Industrial Development

5 Kiora Crescent, Yennora

Flood Study Report - Issue 01

10 Schedule A - Responses

Figure A5.1 Standard Flood Fence Detail – SD 8025

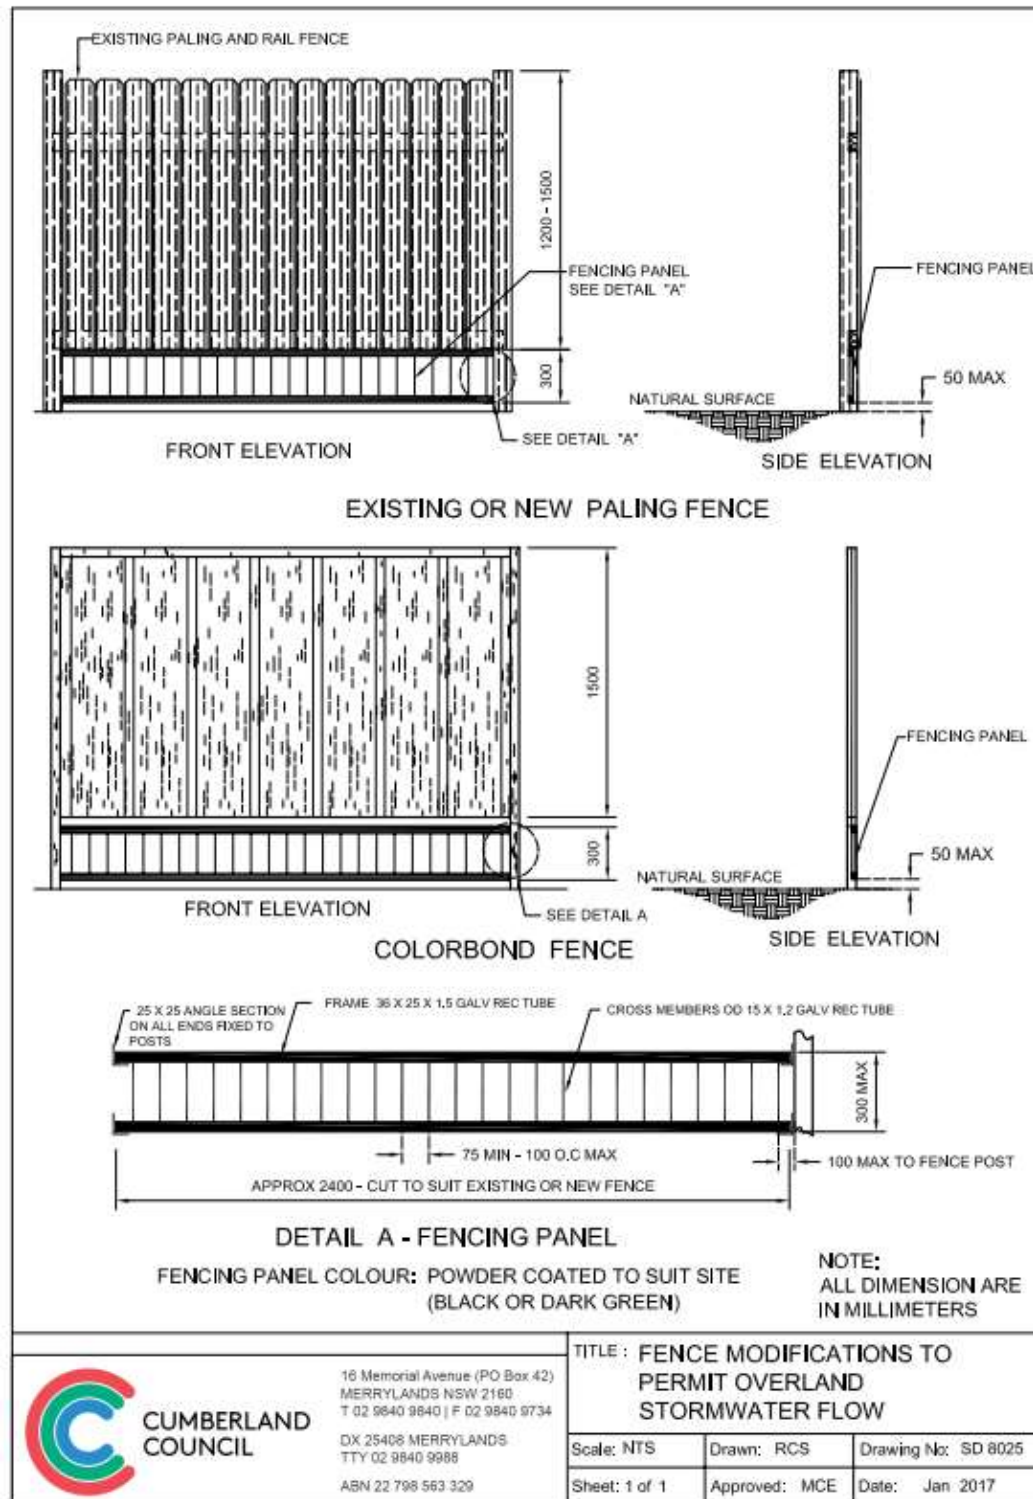
2. DADCA03- Boundary Fencing Flood Affected Areas

The development site has been identified as a flood affected site in the 1% Annual Exceedance Probability (AEP) storm event. In order to ensure fencing does not result in the undesirable obstruction of the free flow of floodwater, Council's relevant Development Control Plan requires that all boundary fencing within the flood affected area(s) as identified in the submitted flood report [to be constructed in accordance with Council's standard detail SD8025. This involves pool type fencing being provided at the base of the boundary fence to the extent of the post-developed 1% AEP flood. Stormwater plan must denote the location and state the requirement for construction of the fence as per standard drawing SD8025.

[Stormwater plans to denote flood fence in accordance with council's standard detail SD 8025. The standard detail has been included in this report in appendix 5.](#)
